## SYDNEY SOUTH PLANNING PANEL

Panel Reference	SSPP2016SYE109
DA Number	DA16/1239
LGA	Sutherland Shire
Proposed Development:	Demolition of existing structures and construction of a new residential flat building
Street Address:	Lot 1 DP 122354, Lot 2 DP 210456, Lot B DP 356417, Lot X DP 388636, Lot Y DP 388636 – 17 – 23 Mitchell Avenue and 78 Sutherland Road, Jannali
Applicant/Owner:	Winim Funds Management Pty Ltd
Date of DA lodgement	21 September 2016
Number of Submissions:	Seventeen (17)
Recommendation:	Approval
Regional Development Criteria (Schedule 4A of the Act)	General Development over \$20 million
List of all relevant s79C(1)(a) matters	<ul style="list-style-type: none"> <li>• Sutherland Shire Local Environmental Plan 2015 (SSLEP 2015)</li> <li>• State Environmental Planning Policy (Building Sustainability Index: BASIX) 2004</li> <li>• State Environmental Planning Policy (Infrastructure) 2007</li> <li>• State Environmental Planning Policy No. 55- Remediation of Land (SEPP 55)</li> <li>• Greater Metropolitan Regional Environmental Plan No. 2- Georges River Catchment</li> <li>• State Environmental Planning Policy No. 65 – Design Quality of Residential Flat Development (SEPP 6

### Building Height

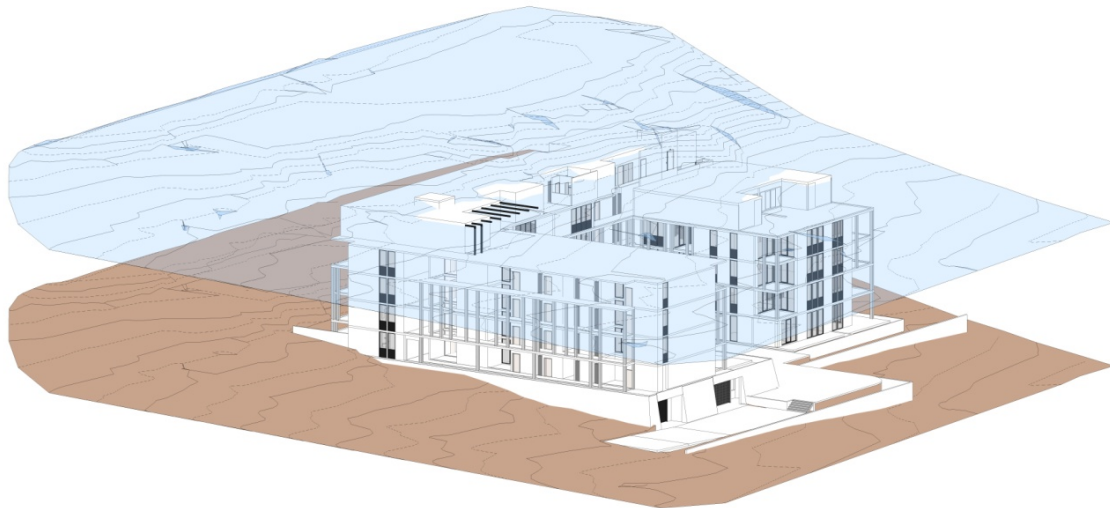
The proposed development fails to comply with the development standard for height. Clause 4.3 of SSLEP 2015 stipulates a maximum height of 16m for this site. The building exceeds the height by a

maximum of approximately 1.02m (7.5% variation). The development exceeds the building height at the eastern projection of Level 3 (Units 308 and 309), the eastern projection of the upper Level 4 floor units and the lift over-runs / plant. The applicants submitted perspective plan depicting the breach above the height plane is provided below.

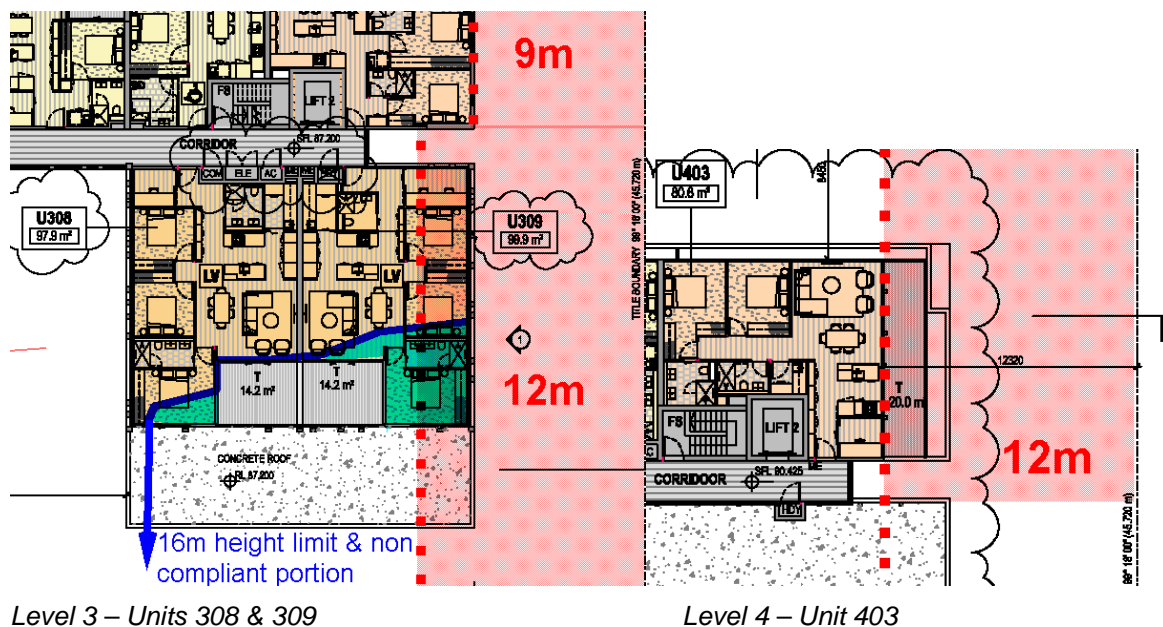
Level 4 and Rooftop - The land falls steeply eastward where in close proximity to the Sutherland Road frontage. The building form attempts to maximise the full permitted 16m height limit and step the building form within the site. This has resulted in areas of non compliances being mainly isolated to the south eastern parts of the upper Level 4 floor units and the lift over-runs / plant areas. The topographical characteristic of the site renders it difficult to realise a building form of a height permitted under SSLEP2015 development standard and avoid breaches in its entirety. This height breaches are mainly located centrally within the roof plan or away from immediately adjoining properties and the sensitive edge of the development where a transition to the adjoining low density residential should be provided. The design of the upper floor appropriately engages and identifies the street corner aspect of the site and provides architectural interest to the building form and does not present a detrimental impact upon adjoining properties, public domain or future occupants of the development in terms of visual intrusion or overshadowing. At this point the variation to the building height standard is acceptable

Level 3 - The northern portion of the Building (in the location of Unit U309) exceeds the height standard. The projection of built form beyond the maximum height control at the sites most sensitive edge is a point where building height should be reduced, not exceeded. As further discussed, Unit U309 also encroaches within the 12m setback required to be provided at the zone interface. It is recommended that a reduction in height, bulk and scale of the Building at the interface with the adjoining low density zoned be provided (consistent with the ADG), particularly the floor space and associated roof form of the master bedroom / bathroom to Unit U309. This in turn removes the majority of roof form which exceeds the maximum permitted height at this point. The resulting projection of built form of Unit 308 is setback further from the property boundaries and stories below and is not anticipated to adversely impact upon the adjoining properties. These design recommendations are anticipated to reinforce and satisfy the objectives of Zone R4 (and the adjacent R2) and the development standard.

Subject to minor design refinement, the development is not anticipated to adversely impact upon adjoining properties or locality in terms of loss of views, loss of privacy, overshadowing or visual intrusion. No detrimental impact is presented in terms of view loss as the loss of any potential views from nearby properties on the western side of Sutherland Road will be of distant views, orientated over a road reserve and a number of properties. The proposal is generally consistent with the desired scale and character of the street and locality including desired future scale and character.

The applicant's submission demonstrates that compliance with the building height development standard is in part unreasonable or unnecessary in the circumstances of the case. It also demonstrates sufficient environmental planning grounds to justify varying this development standard. In terms of scale, the proposed development is in the public interest as the proposal complies with the objectives for both height and the R4 High Density Residential zone. The proposed variation does not raise any matters of State or Regional environmental planning significance. In addition, there is no public benefit associated with arbitrarily reducing the height to the development standard in the

circumstances of this case. In conclusion the variation to the height development standard satisfies all relevant parts of clause 4.6 and therefore the variation can be supported to the extent recommended, subject to a minor design change to Unit 309.
